Access Compliance Report Public Rights-of-Way (Curb Ramps)

Main Street: O_NEILL_DR Cross Street: N/A Location: NE

ADA ID: RPRK211026131751 Ramp Type: Type 4 - Parallel Initial Pass/Fail: Fail Overall Compliance: No Severity Score: 16

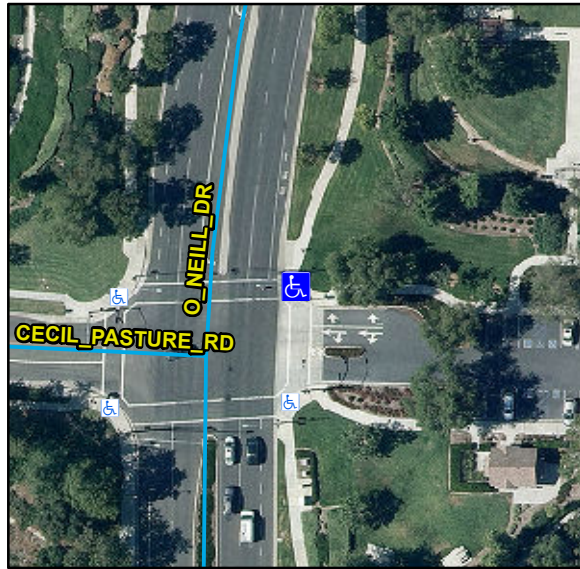
Compliance	Description	Data	Compliance	Description	Data
N/A	Ramp Length LT (in)	92	N/A	Ramp Length RT (in)	100
Yes	Ramp Width LT (in)	90	Yes	Ramp Width RT (in)	90
Yes	Ramp Run Slope LT (%)	7.1	No	Ramp Run Slope RT (%)	8.9
Yes	Ramp Cross Slope LT (%)	0.8	No	Ramp Cross Slope RT (%)	2.9
N/A	Landing Present	N/A	N/A	DWS Provided	N/A
N/A	Landing Length (in)	N/A	N/A	DWS Contrast	N/A
N/A	Landing Width (in)	N/A	N/A	DWS Length (in)	N/A
N/A	Landing Run Slope (%)	N/A	N/A	DWS Full Width	N/A
N/A	Landing Cross Slope (%)	N/A		DWS Offset Type	N/A
N/A	Landing Movement Obstructed?	N/A	N/A	DWS Offset Left (in)	N/A
	Landing Movement Type	N/A	N/A	DWS Offset Right (in)	N/A
N/A	Landing Shared	N/A			
N/A	Clear Space	Yes			
N/A	Clear Space To Crosswalk (in)	48			
N/A	Marked Crosswalk 1	Yes	N/A	Marked Crosswalk 2	Yes
	Crossing 1 Direction	W		Crossing 2 Direction	S
	Marked Crosswalk 1 Width (in)	144		Marked Crosswalk 2 Width (in)	144

Remove & Replace Curb Ramp With Two New Directional Ramps or Equivalent.
